RFI

RFI #: 28
Date: 12/17/2019
Job: 18-075 LDS Wolftrap
Phone:

Subject: Shed/Dumpster Enclosure Dimensions

**CROWELL ROAD
MEETING HOUSE
OAKTON VA STAKE**
CROWELL RD AND HUNTER MILL RD
FAIRFAX, VIRGINIA 20190

A801

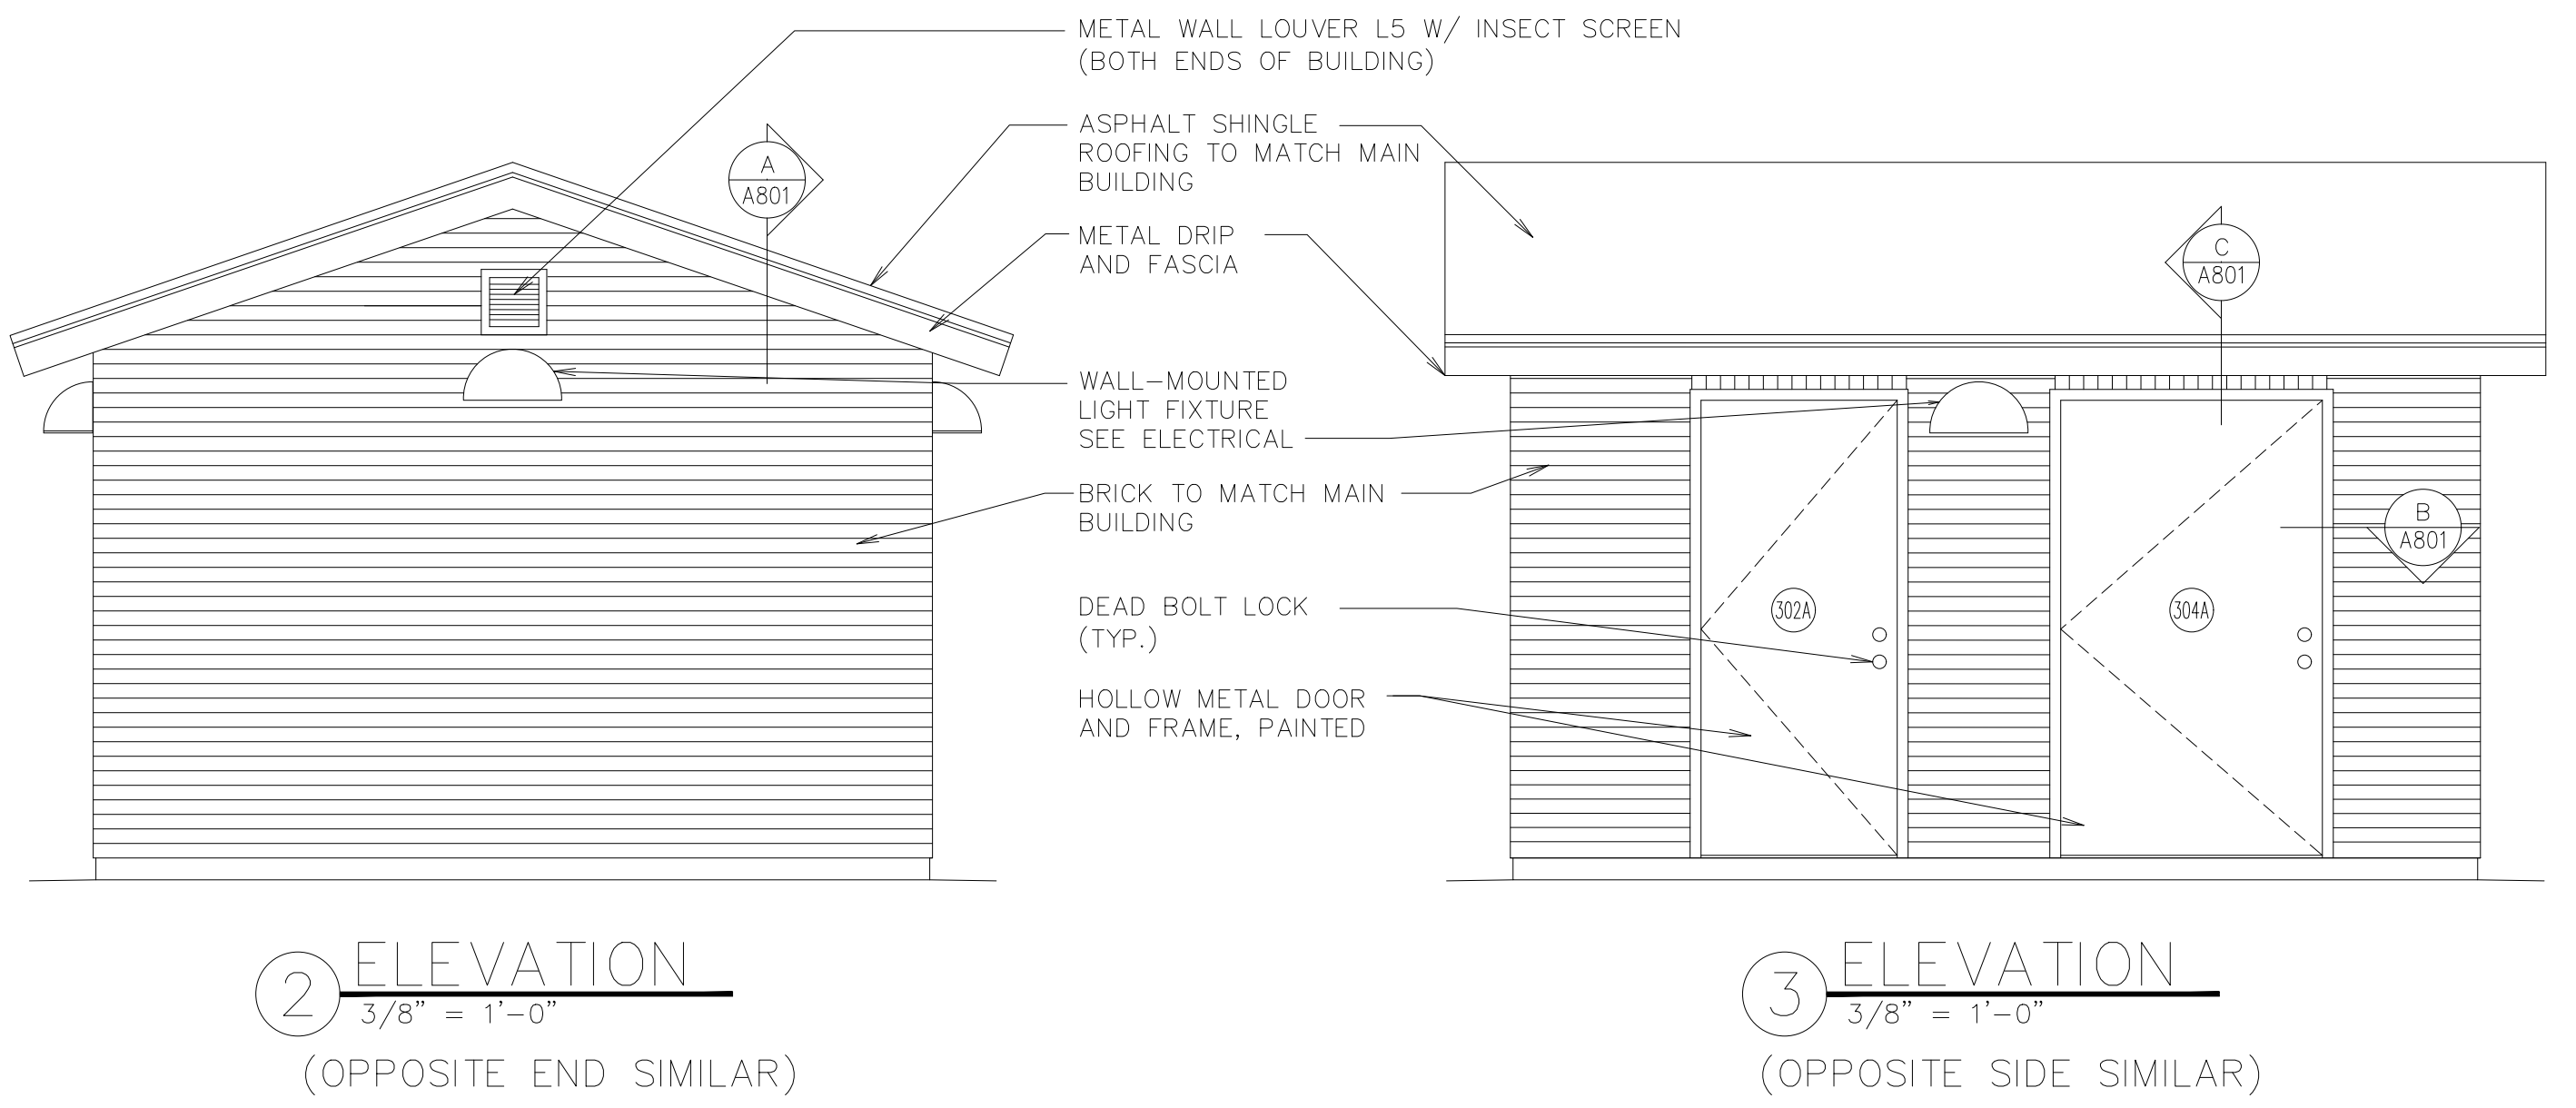
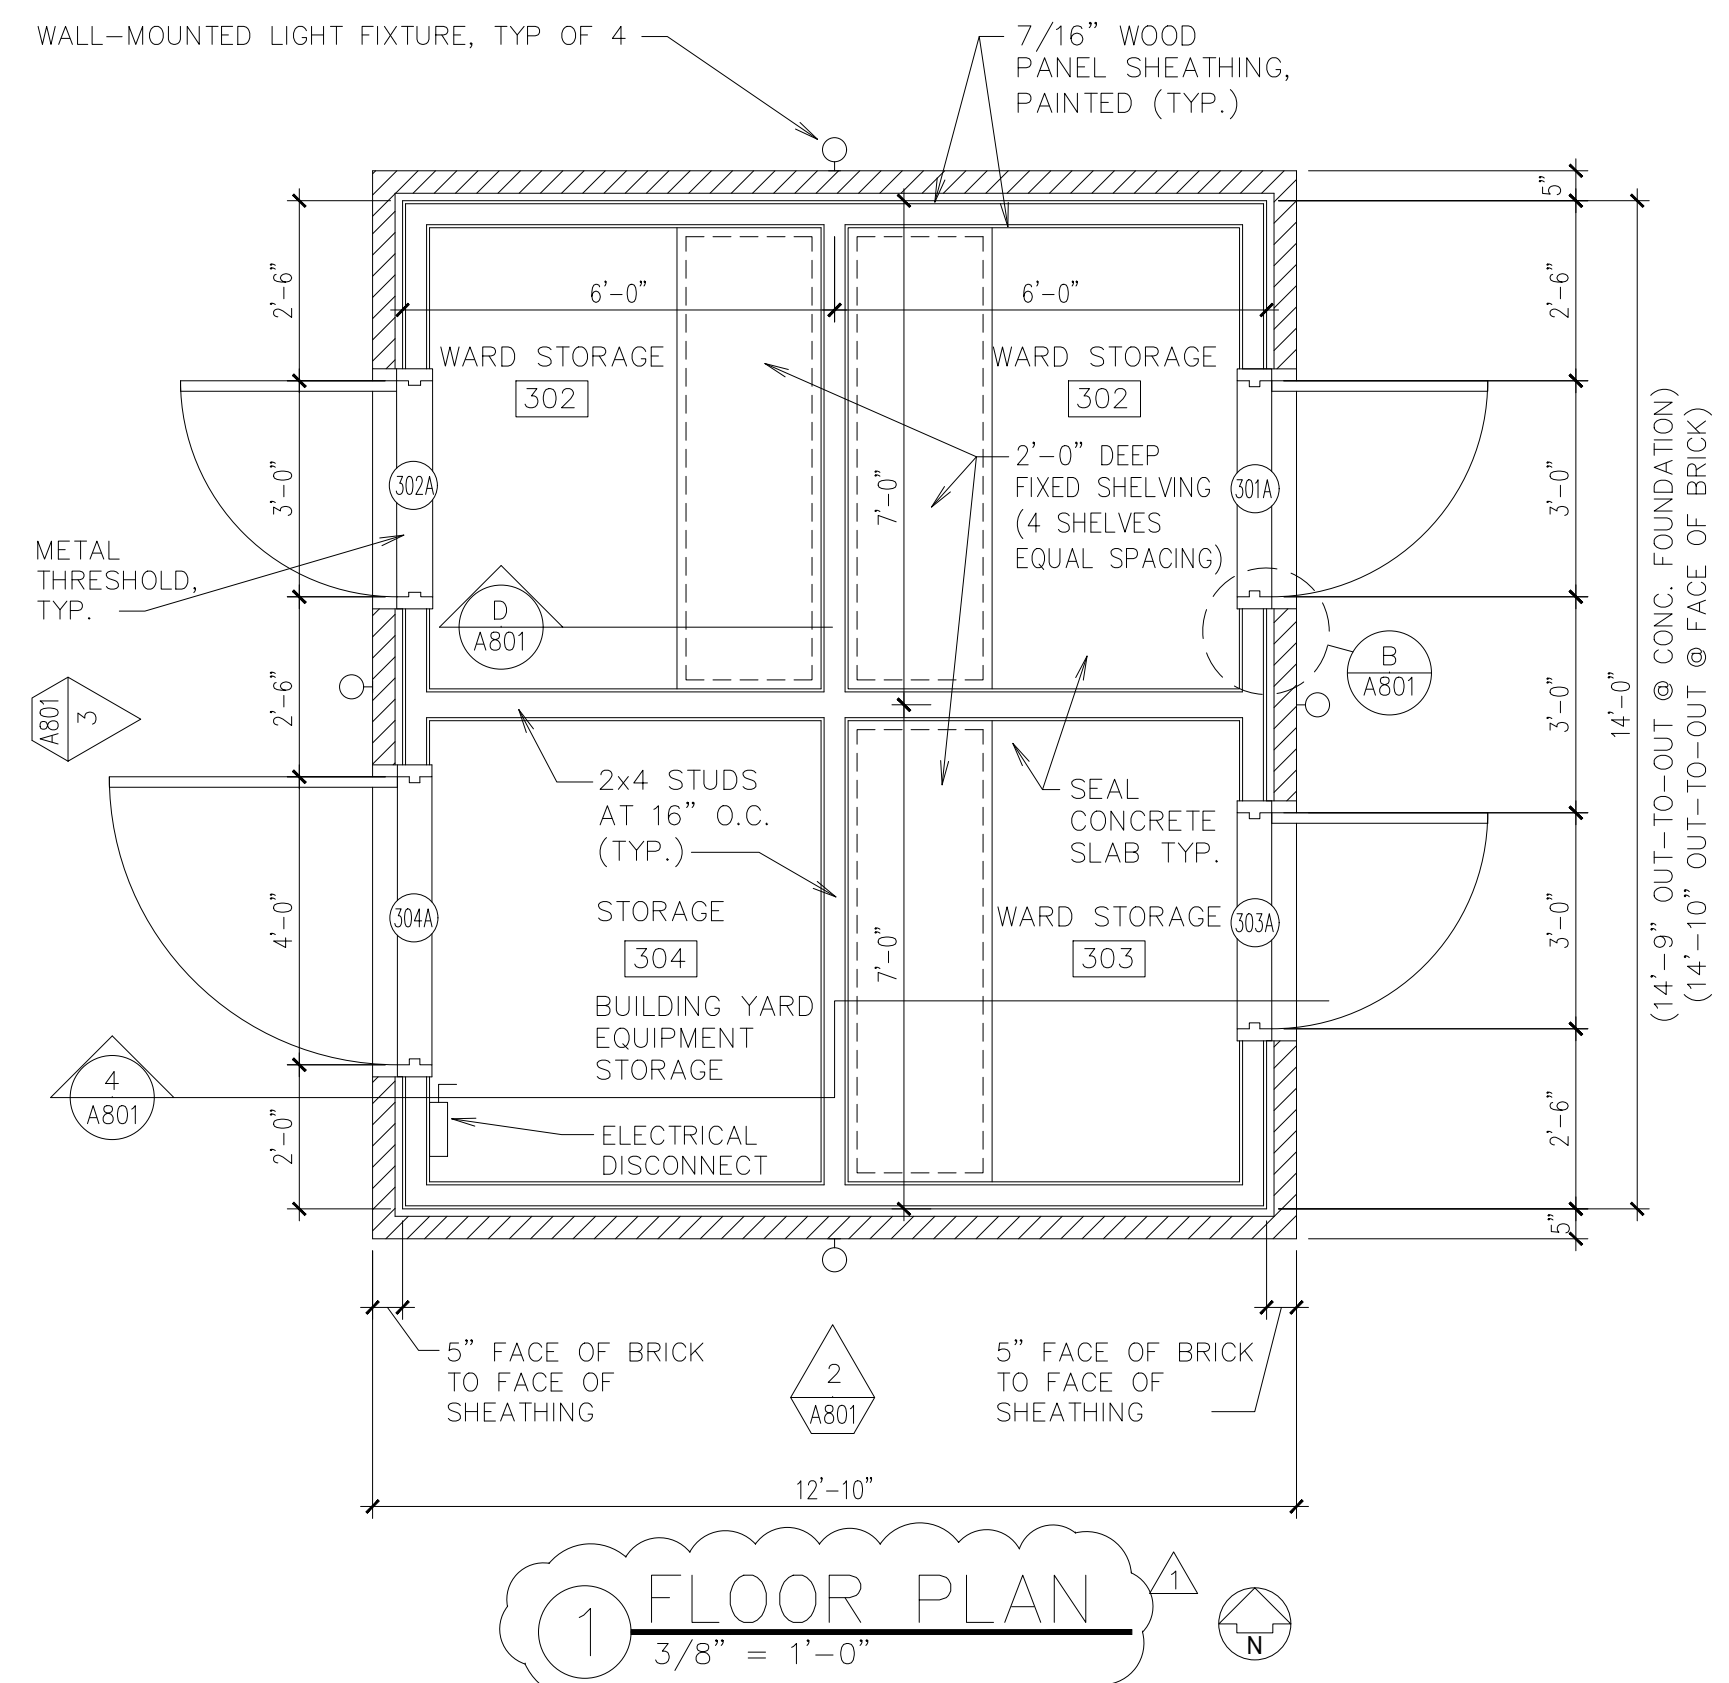
The concrete contractor has noticed a bust in the dimensions that Urban had set in the field. Sheet A801 calls out for the outside of shed concrete foundation to be 12'-9" X 14'-9" and sheet A802 shows the outside brick dimension as 12'. If the dimensions on sheet A801 are to be used the dimensions on sheet A802 will need modified. Can you provide us with the correct dimensions?

Please see attached Sheets A801 and A802, issued with today's date with corrected notes and dimensions. 1/A801, 4/A801 & 1/A802 have been updated in whole or in part, as indicated by the clouds.
